CENTRAL WATERFRONT
DOGPATCH
PUBLIC REALM
PLAN

LAND USE SCENARIOS

WORKSHOP #3

DATE: FEB 8 2017
LOCATION: POTRERO HILL REC CENTER

EXISTING CONDITIONS

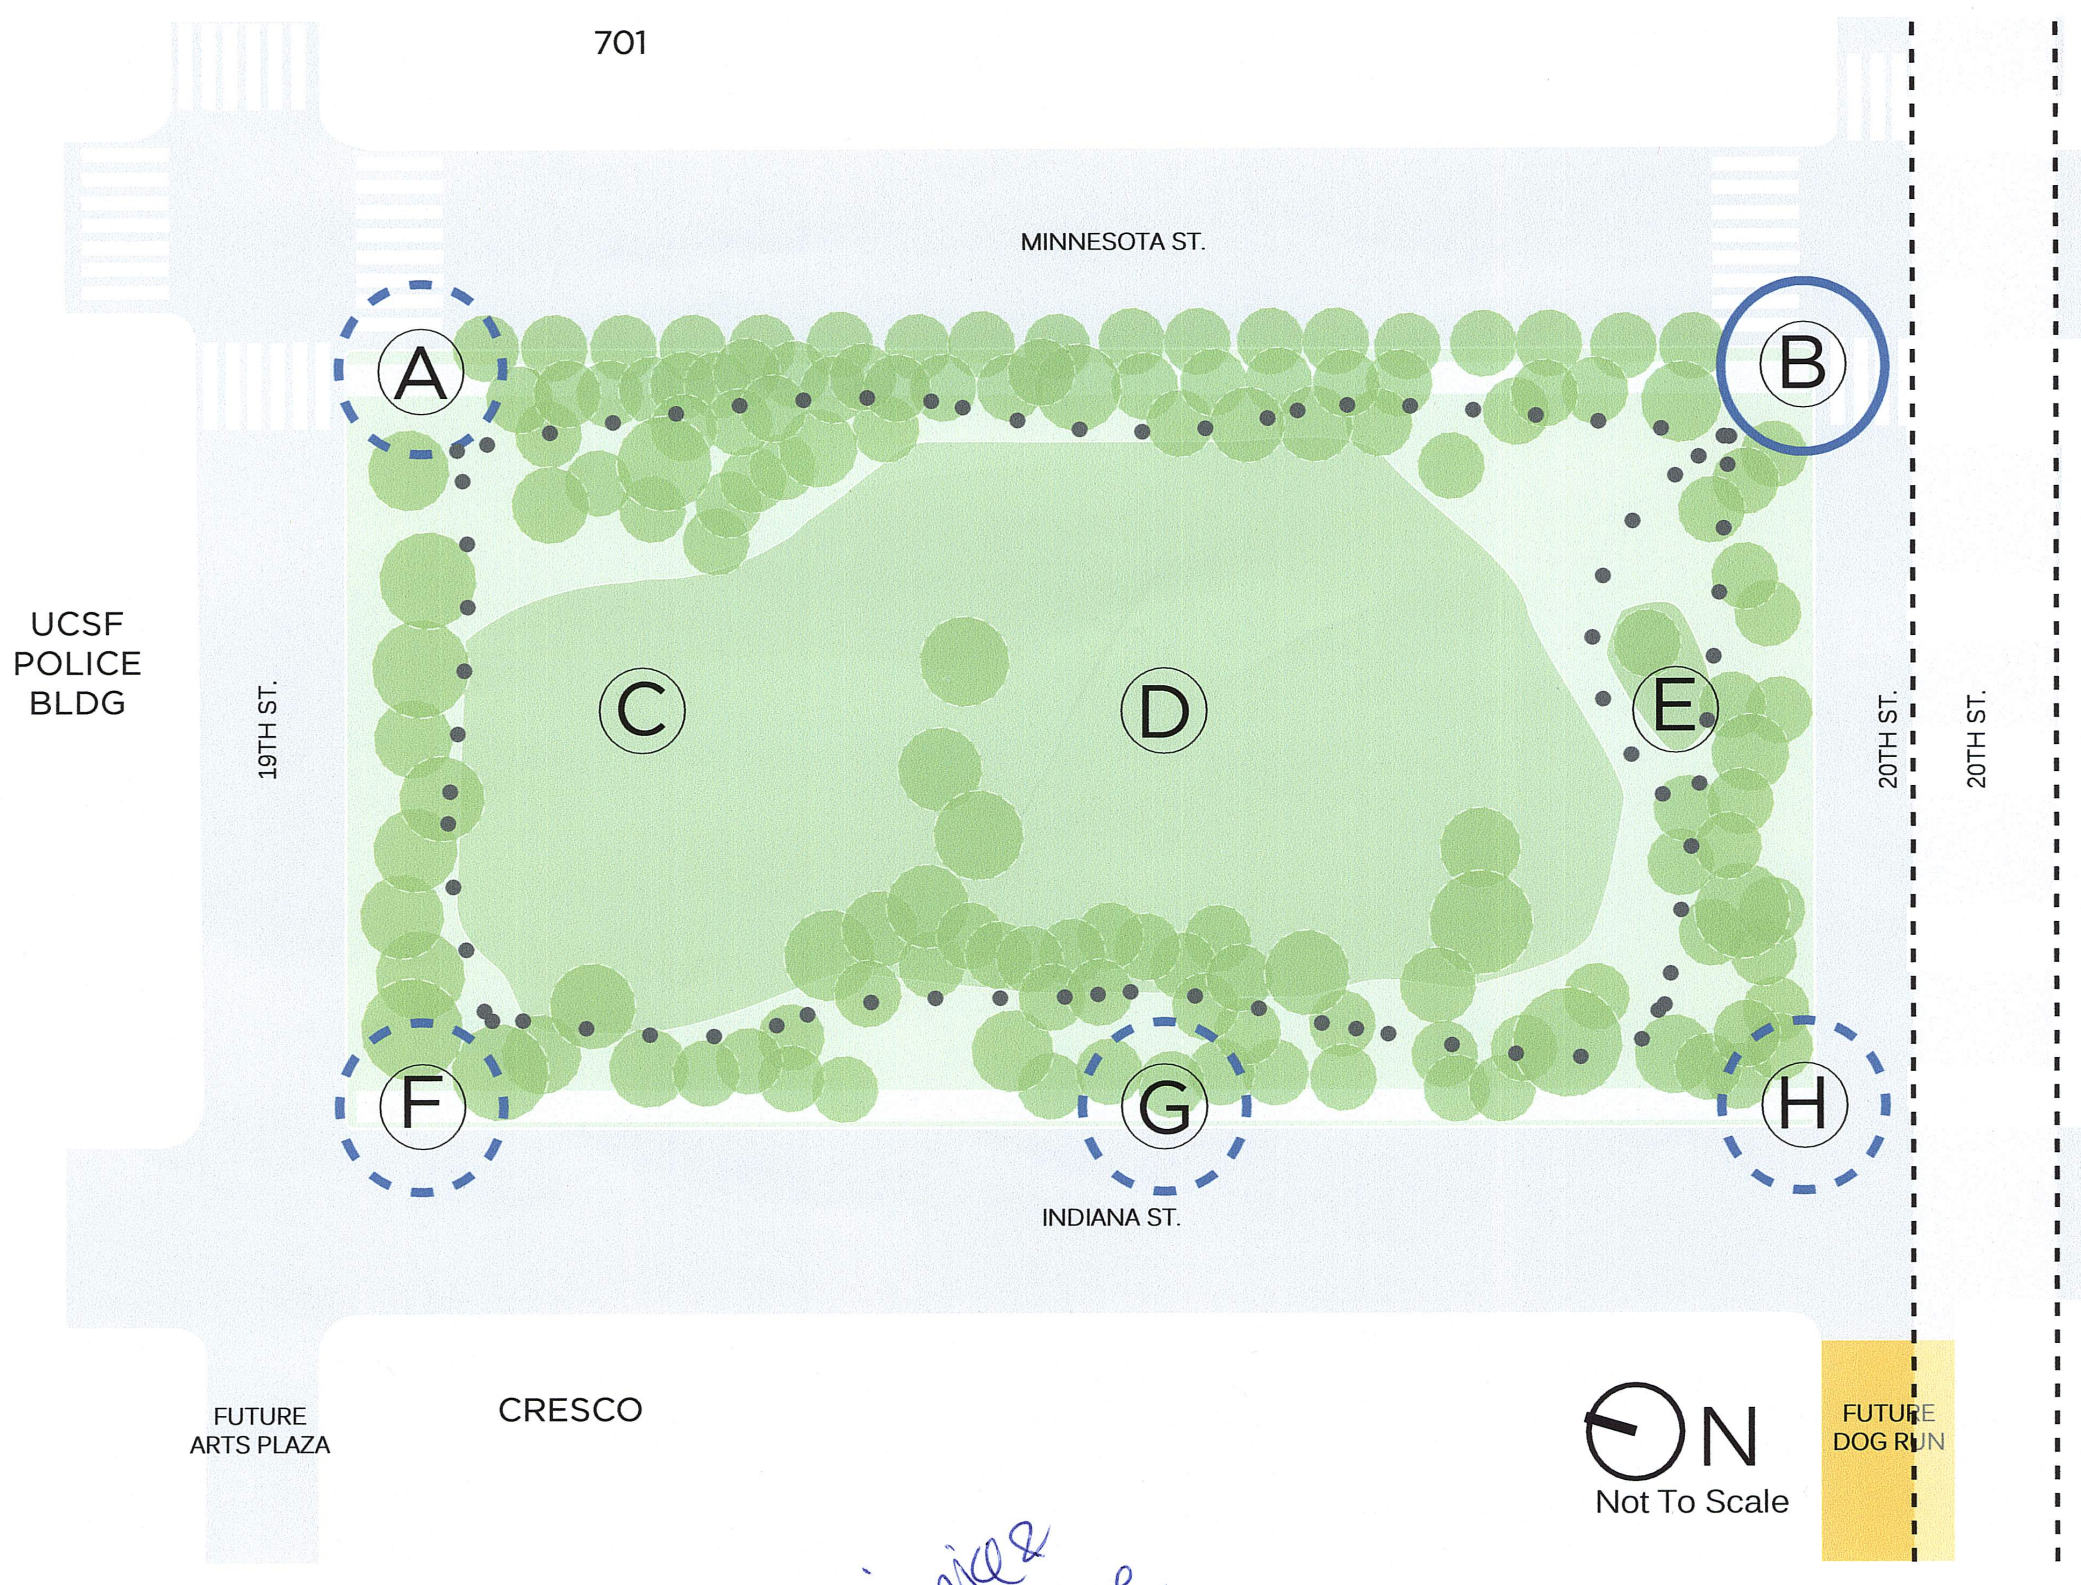
This is nice & unobtrusive

None of the scenario's address a new or upgraded Adult rec equipment. Would like to see a consolidated ~~area~~ Adult rec area.

SCENARIO 1: EXISTING MEADOW SIZES, DOG PLAY AREA IN NORTH MEADOW

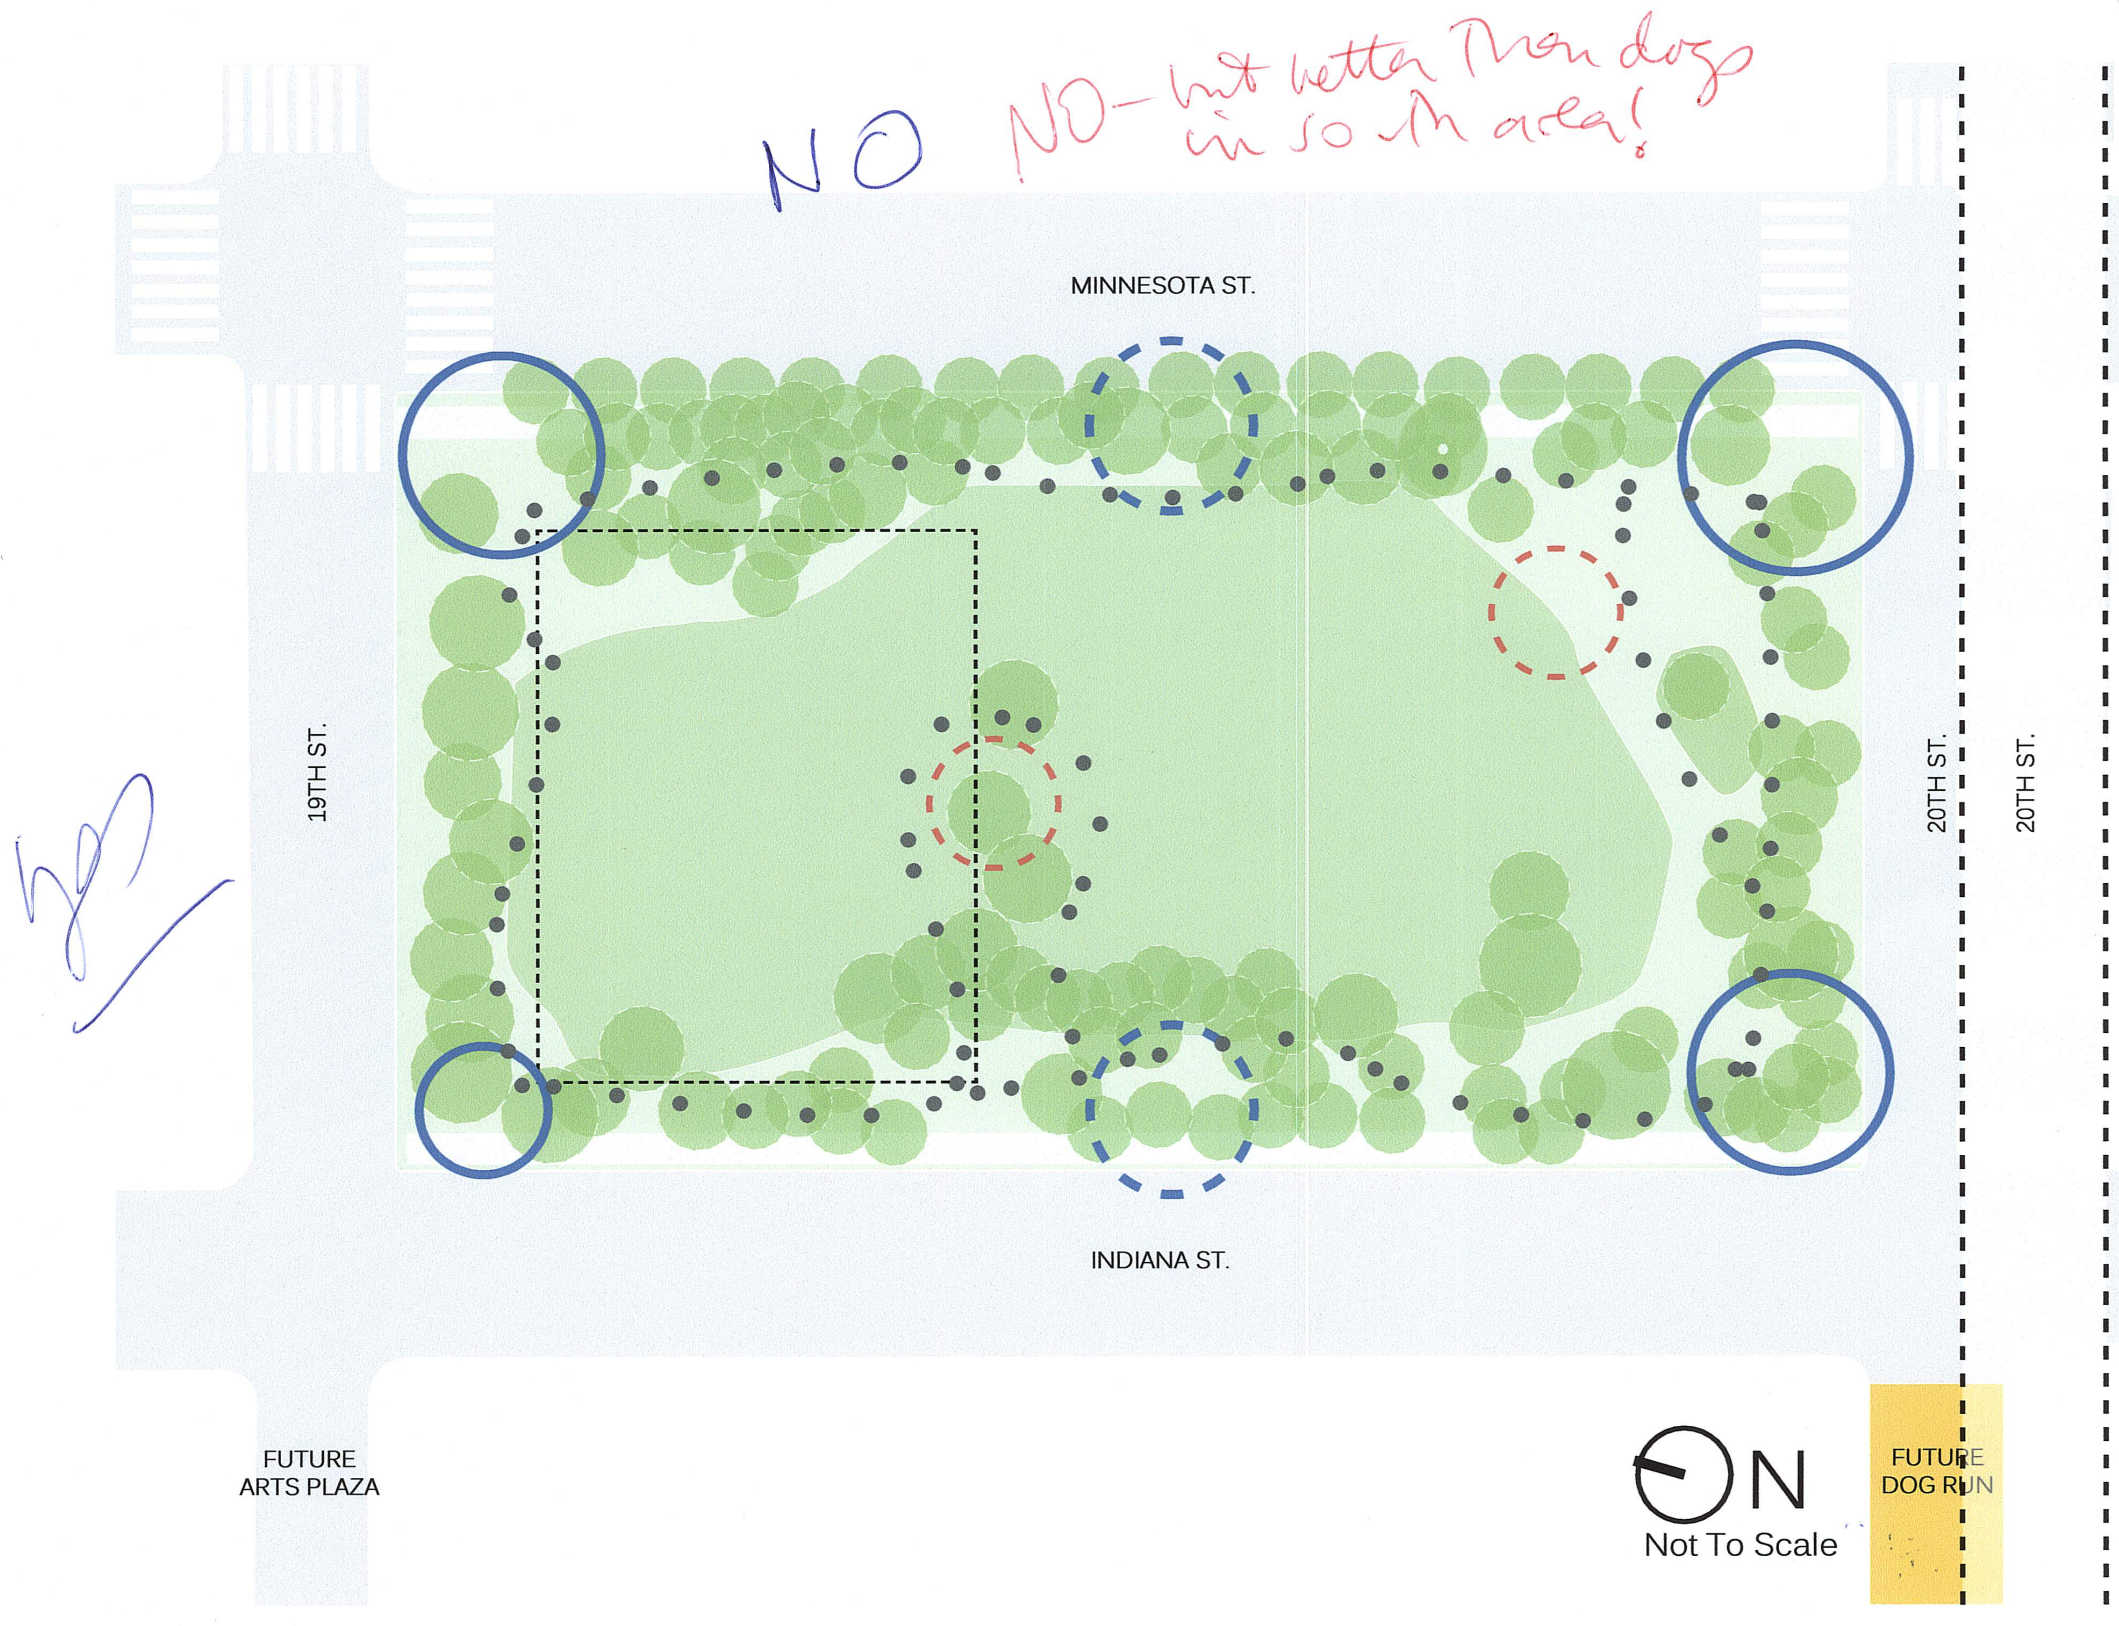
NO

NO- but better than dogs in south area!

No

QUESTION: CURRENTLY THE WHOLE PARK IS USED FOR DOGS; THE FIELD IS ROTATED DUE TO THE DOGS DISTRUCTIVENESS — WON'T THIS BE NEEDED IN FUTURE?

CONSIDER
① ROTATING DESIGN FOR TURF UPKEEP.
② LIMITED ~~PLAZA~~ AREA FOR PEOPLE ONLY- (EATING, SUNNING.)
③ EXPAND PUBLIC REALM VIA SHARED STREET.

JM

JC - worst of the worst.

Yes,

COMMENTS: This approach doesn't align with current usage = Bad

North meadow too small and most frequently used by kids.

BEST OPTION

Yes better proportion for (human) population that will triple by 2020

Yes, less dog play area — don't designate if too heavily though ← More no-kid families moving in. Dogs more likely, young professionals, too.

this is too restrictive for dogs (LH)

More dogs coming to 'hood less families, more tech

No, too small.

BETTER, MORE EQUITABLE DIVISION NEEDED.

SCENARIO 2: EXISTING MEADOW SIZES, DOG PLAY AREA IN SOUTH MEADOW

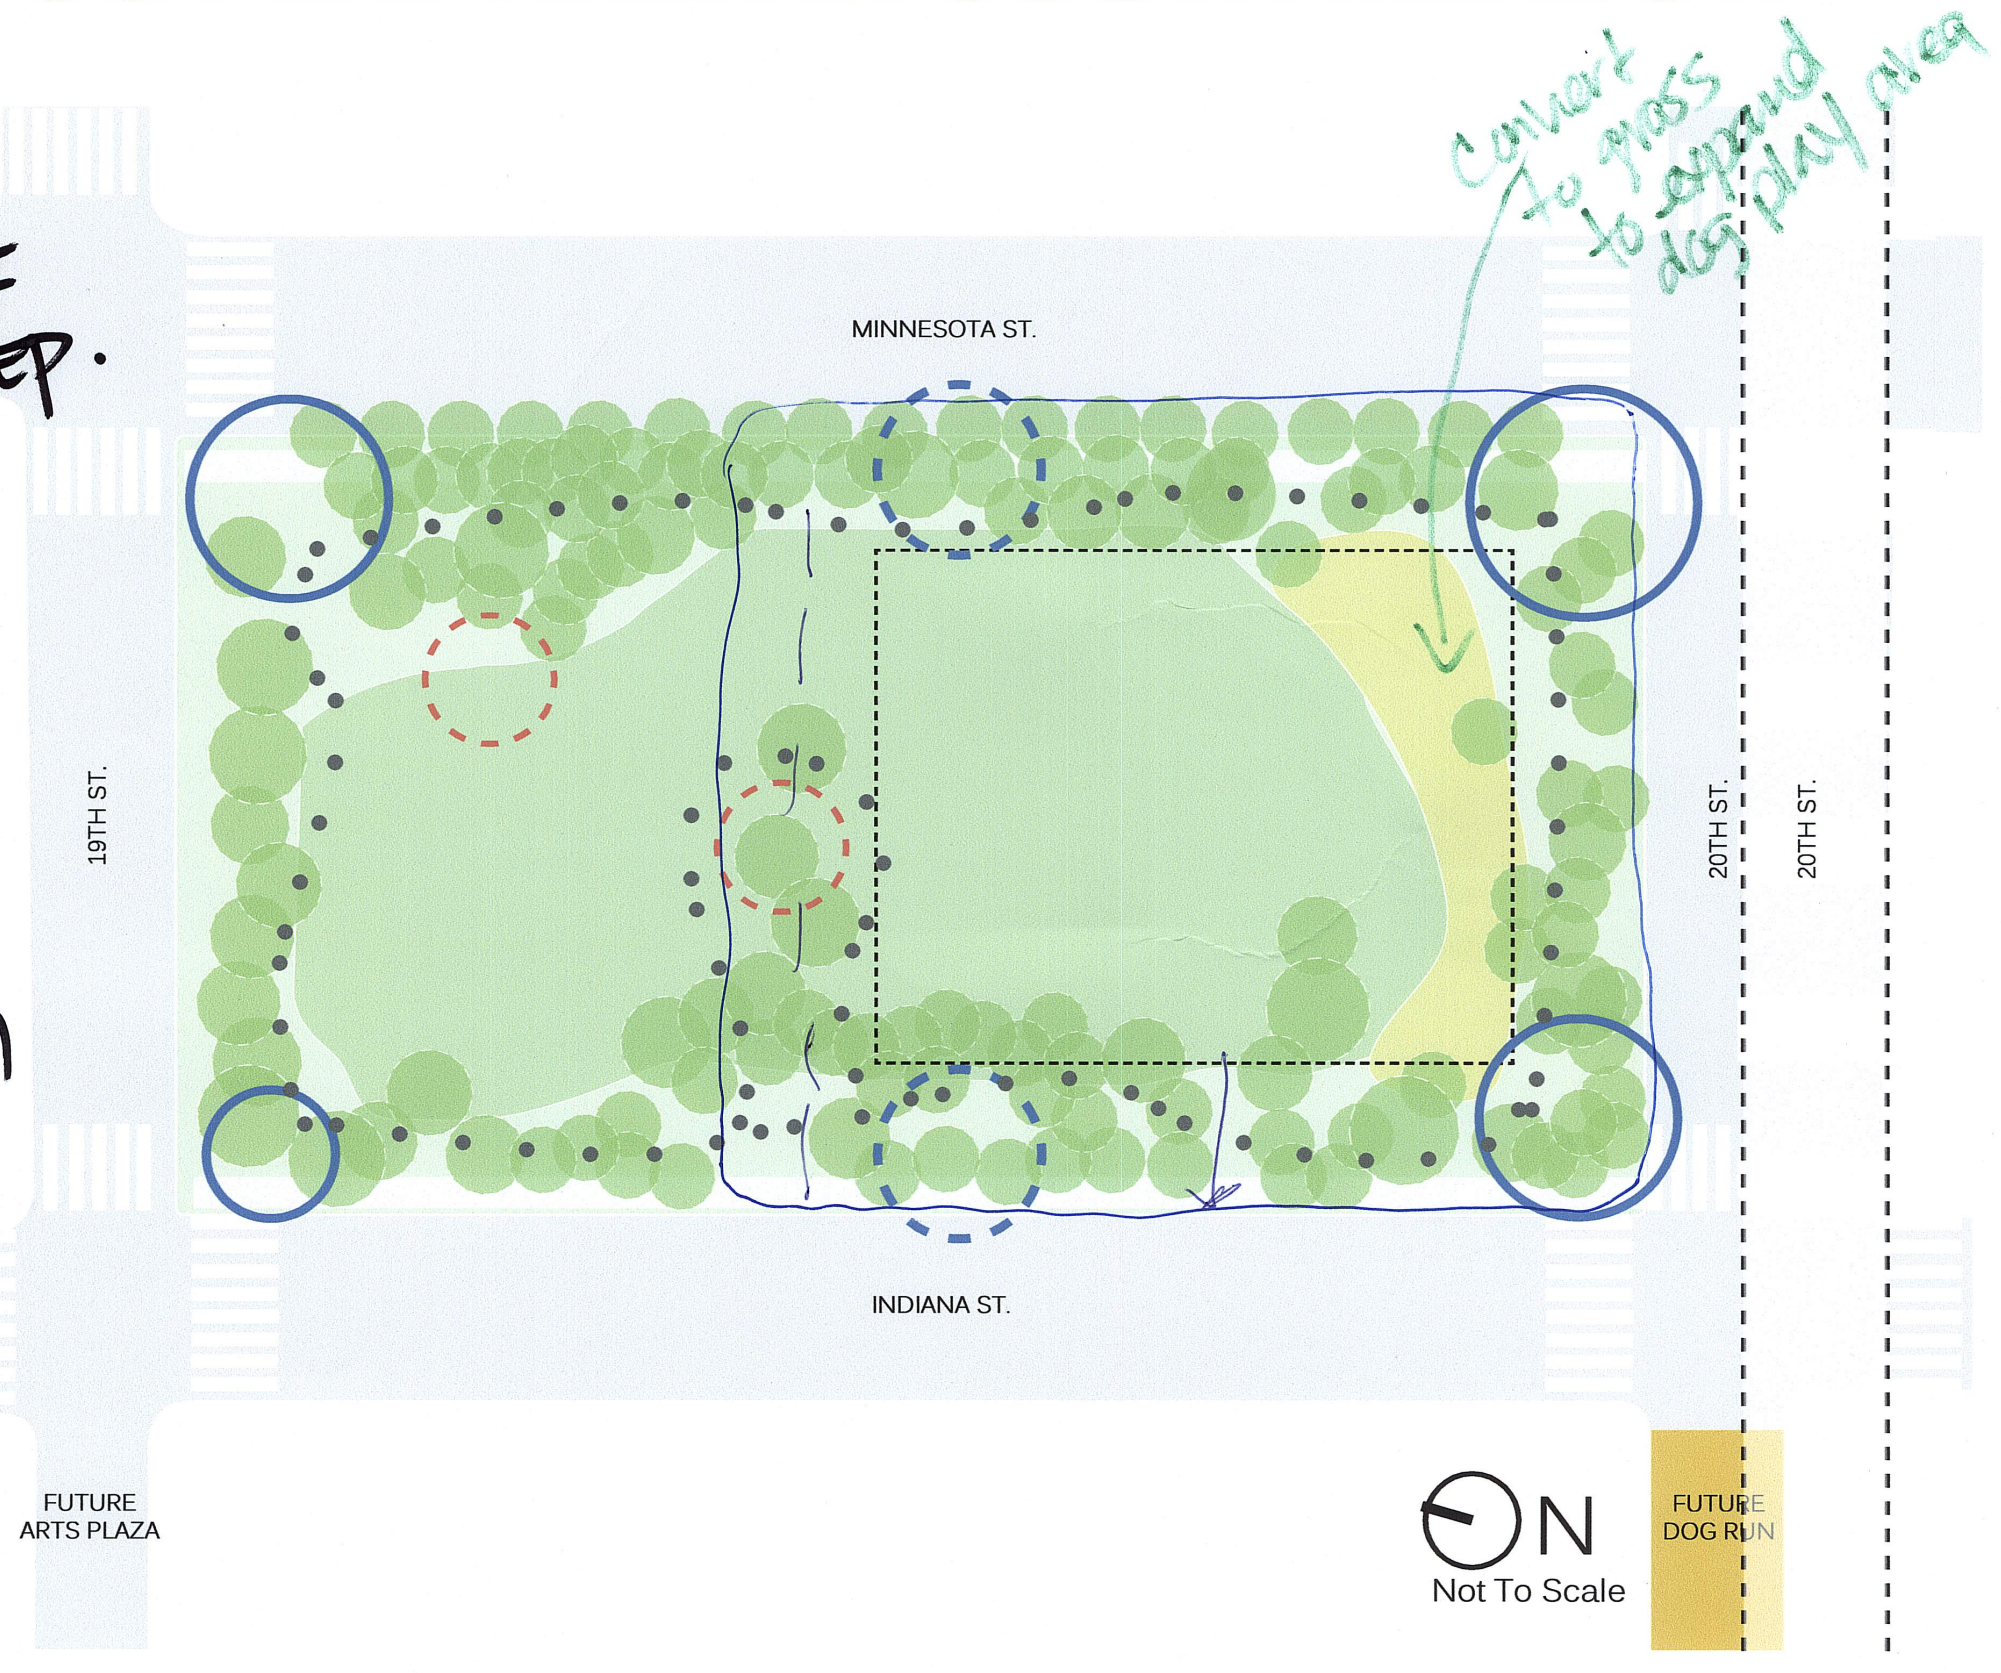
Convert to grass to expand dog play area

COMMENTS: •RE- don't exclude paths

Keep the trees where they are

Yes

Entries are great as they are!

This aligns with current usage, seems great!

This is what everyone already does; people have already implicitly voted for it!

Agreed ↑. This allows appropriate space for both dogs + children

this is the best option!! (LH)

Devide the use of the park and follow the Duboce model and upgrade the PAR course

NO — the south is the sunny warm area — should be for people

yes. People w/ dogs are people.

those who actually recreate need the sunnier larger side.

LIKE THIS OPTION.
